## V2500-A5/D5 SERIES PROPULSION SYSTEM SERVICE BULLETIN

This document transmits Revision 1 to Service Bulletin EV2500-72-0486 and Revision 1 to the Supplement

# V2500-ENG-72-0486

ENGINE – HP COMPRESSOR VARIABLE VANES – INTRODUCTION OF A REVISED VIGV WITH AN  
OPTIMISED SPINDLE – MOD 72-0486

GENERAL SECTION SECTION THROUGH HP COMPRESSOR  
BEFORE ALTERATION  
TYPICAL 38 POSITIONS  
(LONG SPINDLE)

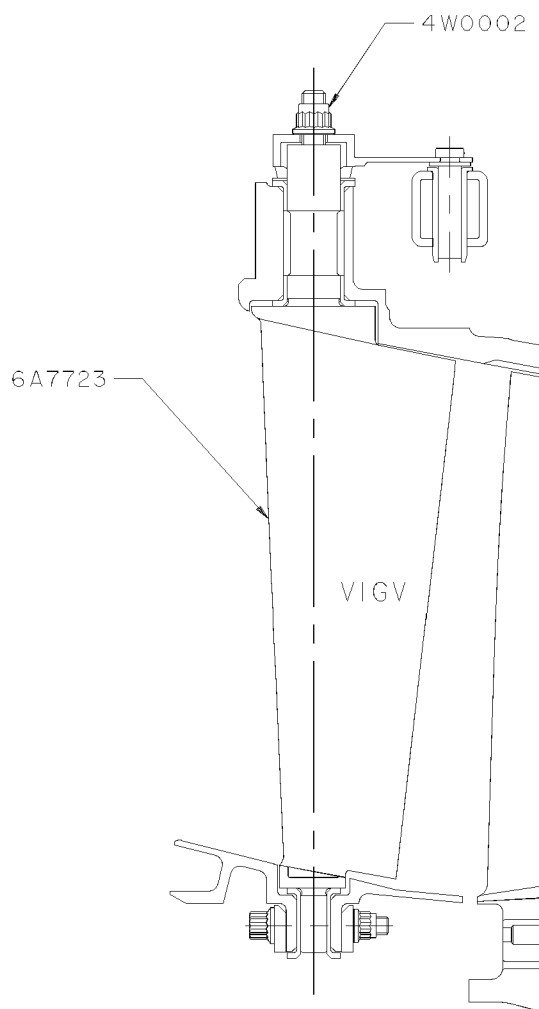
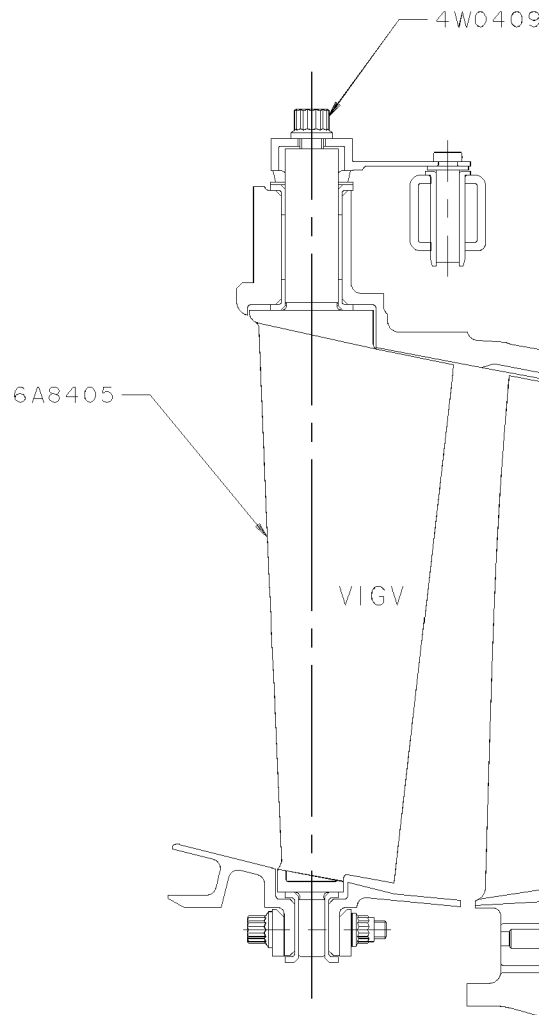
(1) This modification introduces revised arrangement for attaching the Lever arms to the top of the VIGV spindles from the existing stud and nut to a bolt and helicoil configuration. The changes introduced are:

(b) The stud in the top of the vane outer spindle is deleted and replaced by a helicoil insert.

(i) The existing thread size is reduced from 0.3125 UNJF to 0.2964 UNJF.

(ii) The depth of the outer spindle hole has been increased.

(iii) The counter bore diameter has been reduced from 8,68mm. to 7,80mm.

(iv) The weight relief areas on the long spindle are removed.

(c) The nut which was previously used to attach the lever arms to the top of the vane spindles is deleted and replaced by a standard type bolt.

Position for the Variable Inlet Guide Vanes (VIGV) - Fig. 1

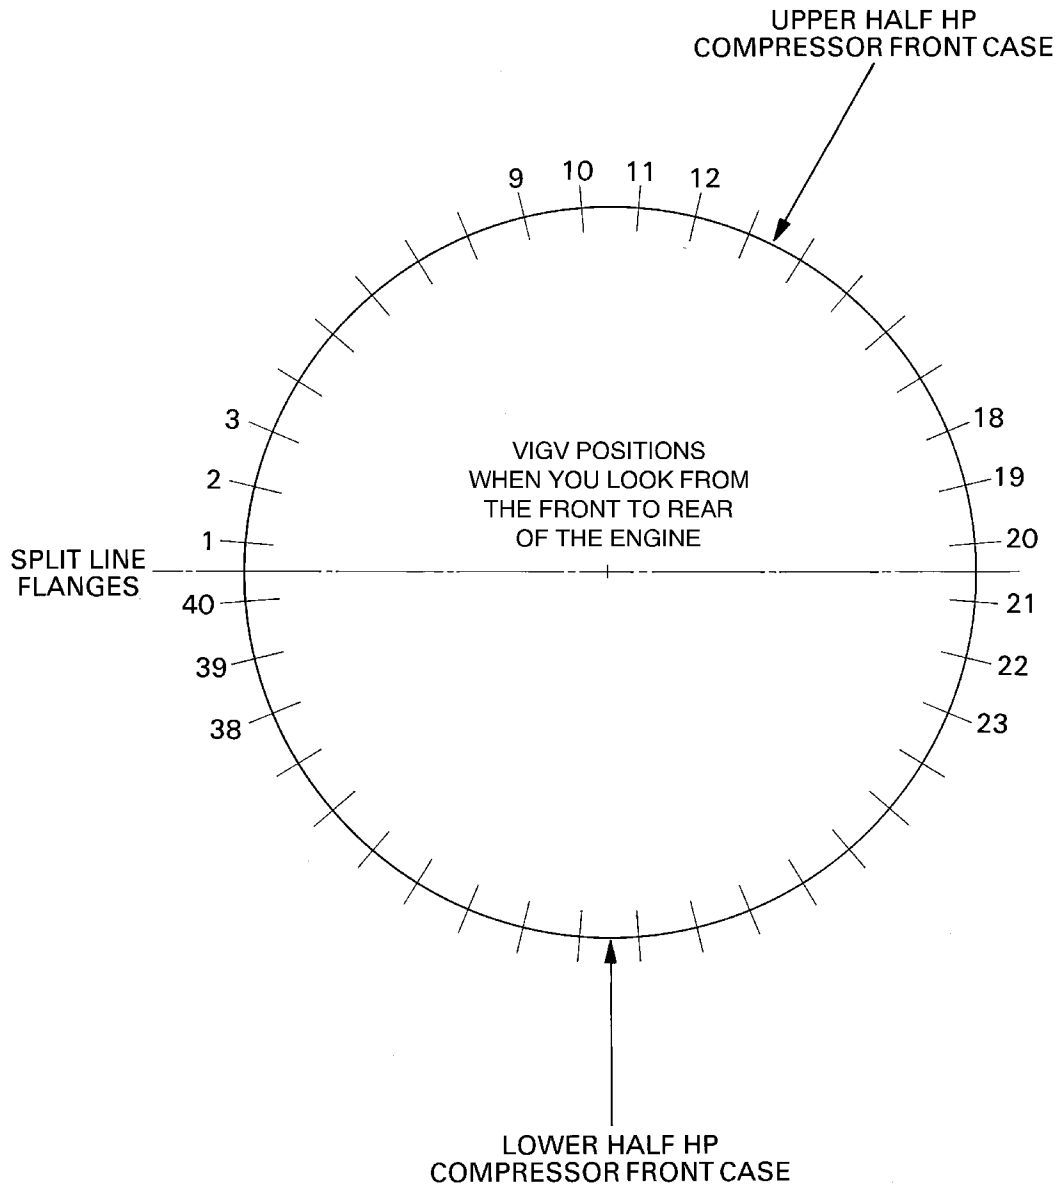
#### C. Assembly Instructions, Refer to Fig 1.

- (1) Install the actuating levers (72-41-34, 02-100 and 02-140). Make sure the correct actuating lever goes on the correct guide vane at positions 3 to 18.
- (2) Install the 16 bolts (72-41-34, 02-102 and 02-142) on to the guide vanes at positions 3 to 18.
- (3) Install the actuating lever (72-41-34, 02-120). Make sure the correct actuating lever goes on the correct guide vane at positions 1, 2, 19, 20, 21, 22, 39 and 40.
- (4) Install the 8 bolts (72-41-34, 02-122) on to the guide vanes at positions 1, 2, 19, 20, 21, 22, 39 and 40.
- (5) Remove the rigging pins and set the guide vanes at the null position.
- (6) Torque the bolts to 100 lbfin. (11,50 Nm.) plus the run down torque.
